Jean Fraser - Planner
City of Portland
Planning & Urban Development Department
389 Congress Street
Portland, ME 04101

Subject: Munjoy Heights
 Final Level III Site Plan Application
 Comment Response Letter

DRAWING NAME: FIRE TURNAROUND PLAN
 PROJECT NAME: MUNJOY HEIGHTS
 CLIENT: REDFERN MUNJOY, LLC
 P.O. BOX 8816, PORTLAND, MAINE 04104

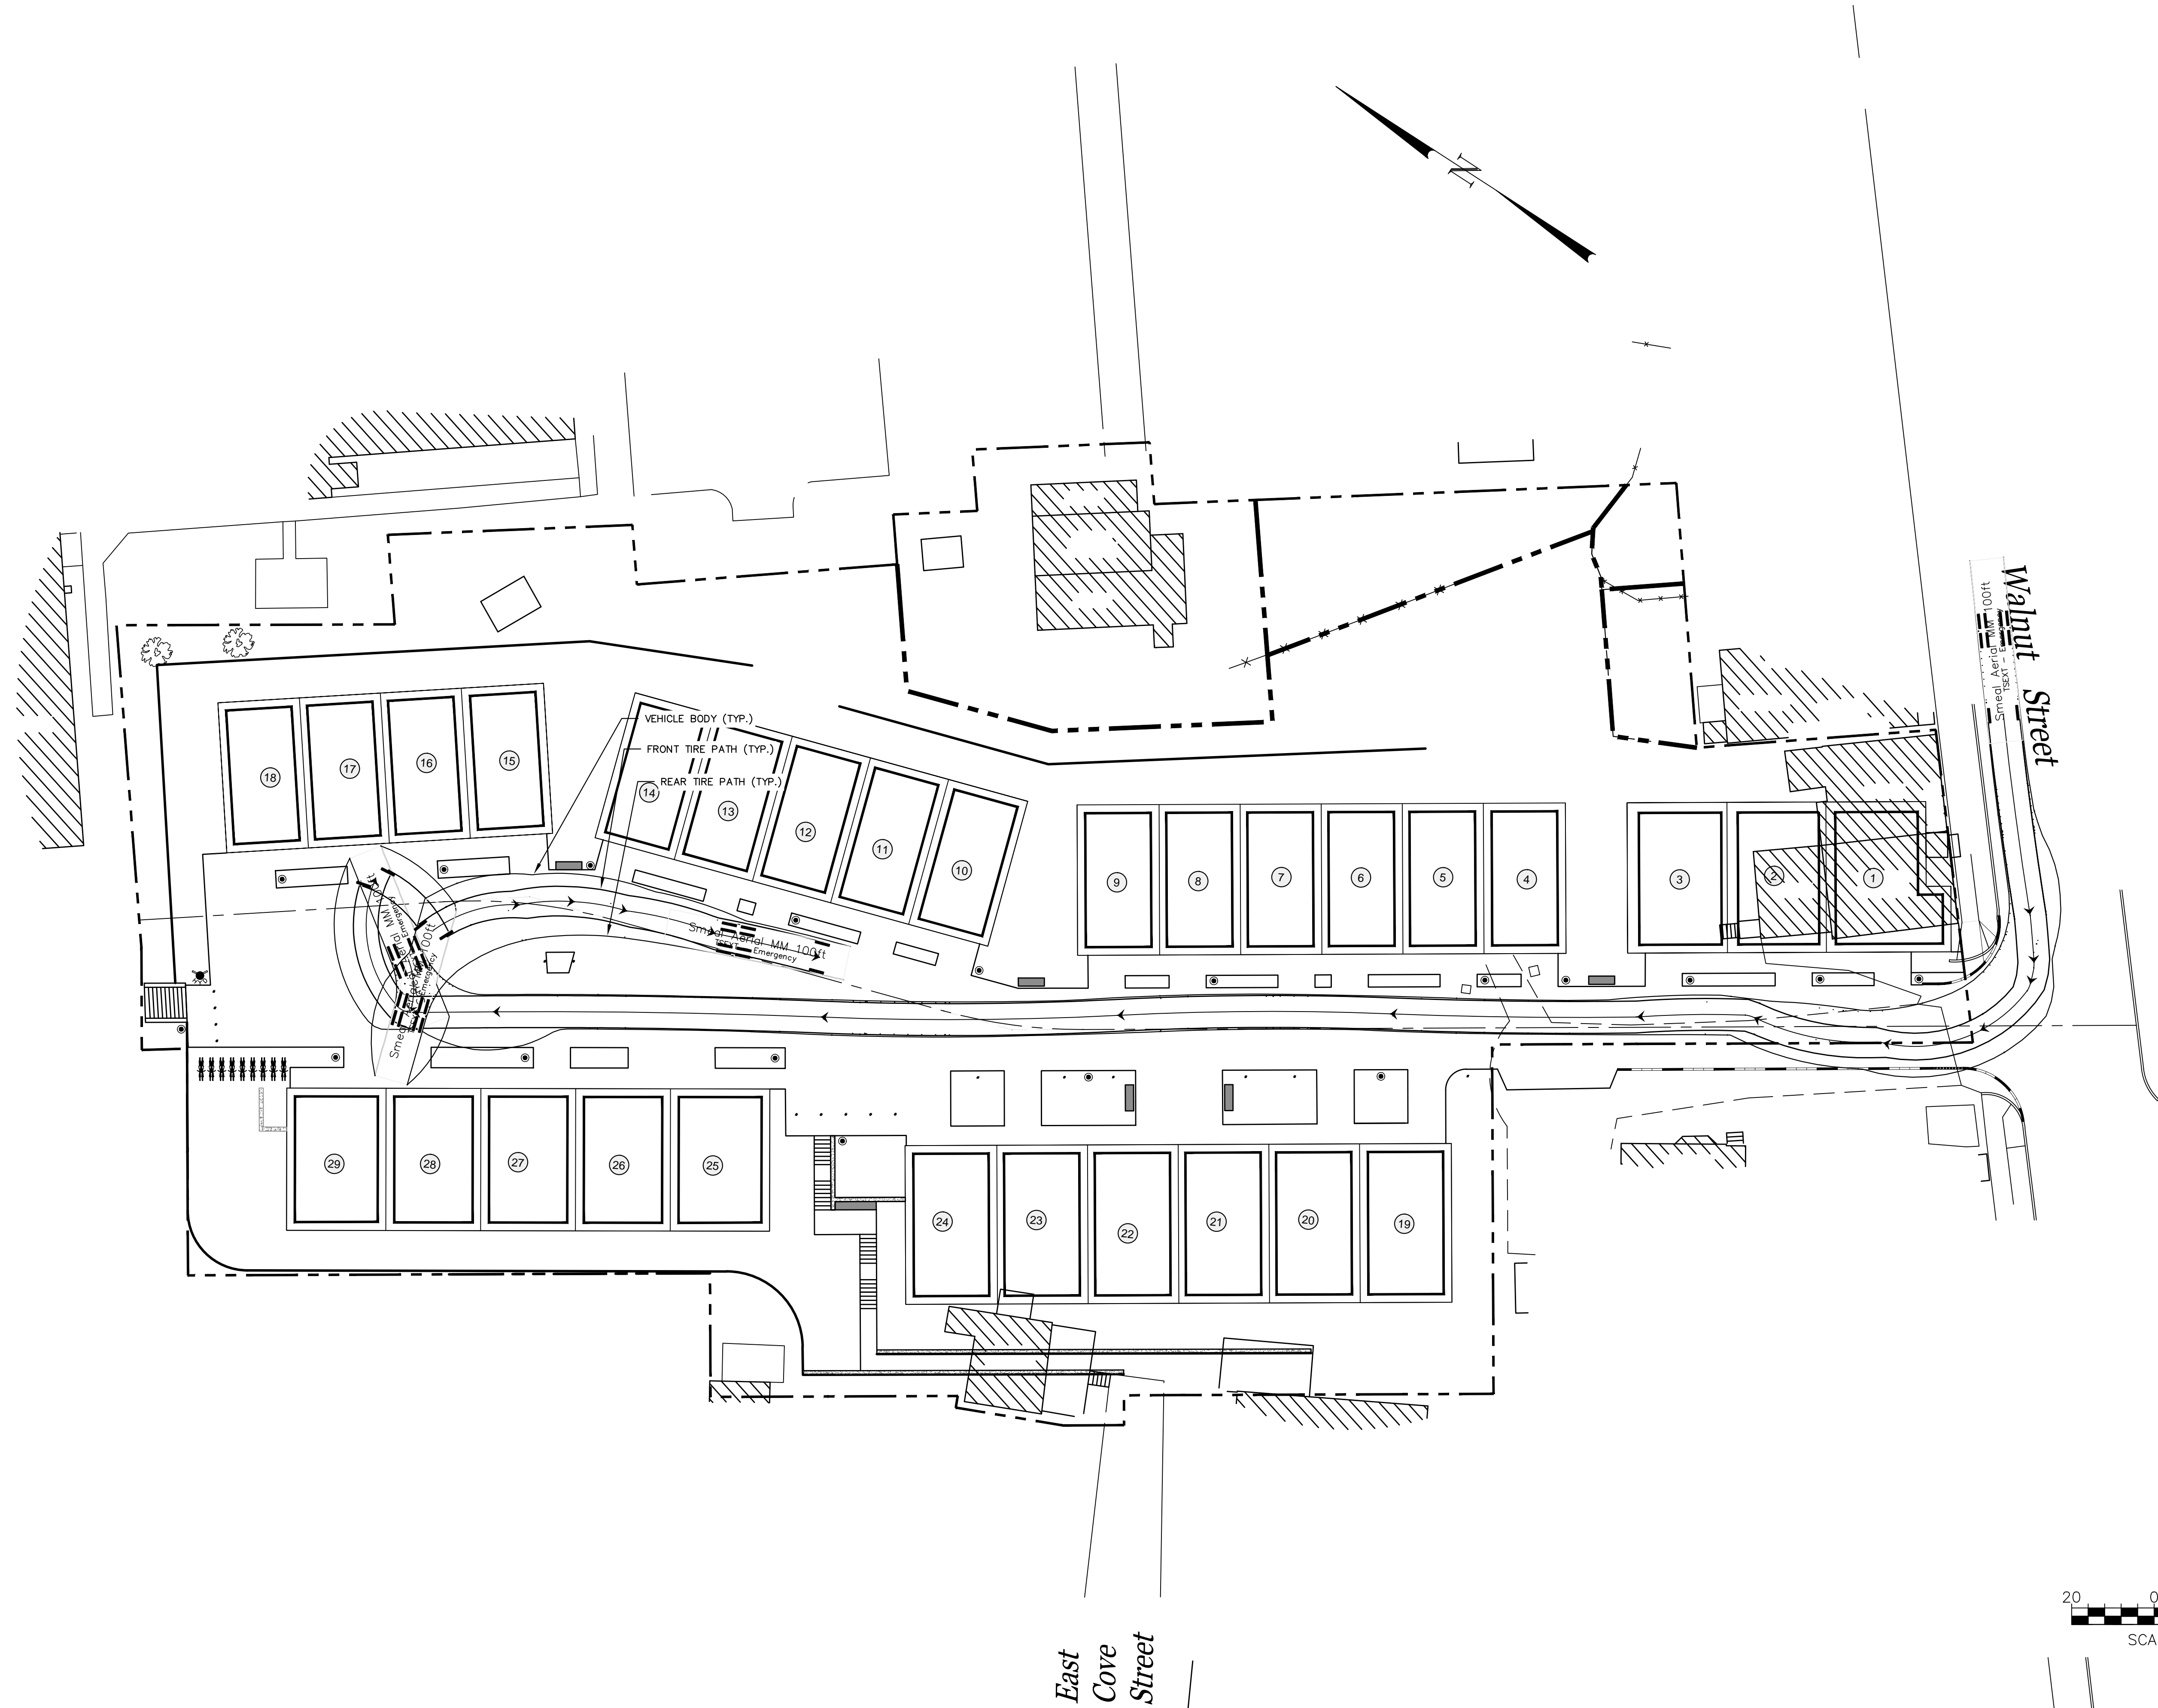
2) *Traffic Comments Email from Tom Errico, P.E. –November 20th, 2013.*

- Acorn Engineering has updated the Fire Truck Turnaround Plan that depicts the ability for a Smeal Aerial MM 100 ft fire truck to access the woonerf driveway and turnaround and the end. Please refer to the attached Fire Truck Turnaround Plan. As a result, we believe the driveway entrance radii is acceptable.
